Site Plan Review Committee (SPRC)
Staff Report for
4600 Fairfax Drive (Ballston Holiday Inn)
SPLN21-00008 (SP #57)

4600 Fairfax Drive (SPLN21-00008)
Ballston Holiday Inn Site
(RPC#s 14-053-055, -056, -023, 14-054-020, and -008)

DATE: February 16, 2023
TIME: 7 – 9 pm
PLACE: Room 311 (BGC) / Microsoft Teams

Proposed Site Layout:

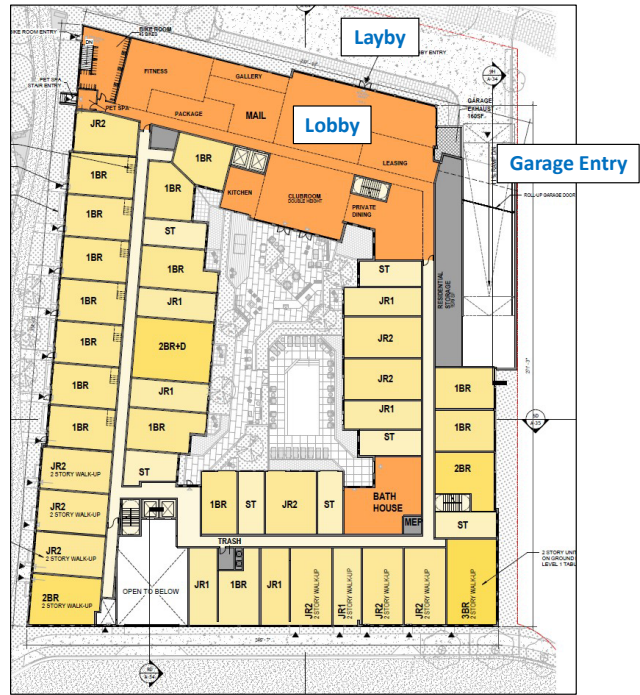
- Work with staff on a pedestrian-friendly treatment of the layby
- Work with staff on design/signage of eastern curb cut to prevent left turns
- Better integrate multiuse trail southern terminus
- Emergency access/mountable curb security restrictions; adding permeable paving

- Study aligning Building #1 garage entry with the signalized intersection at Fairfax Drive and move the residential lobby westward, closer to Metro.
- Study undergrounding loading for Building #1, with access from Fairfax Drive. In conjunction, add residential units to the south side of the building.
- Orient triplex Building #4 to face the new road, or explore front-loaded units.

- Explore additional trees and plantings along the Fairfax frontage.
- Explore adding street trees along the north side of the new service road (east-west segment).
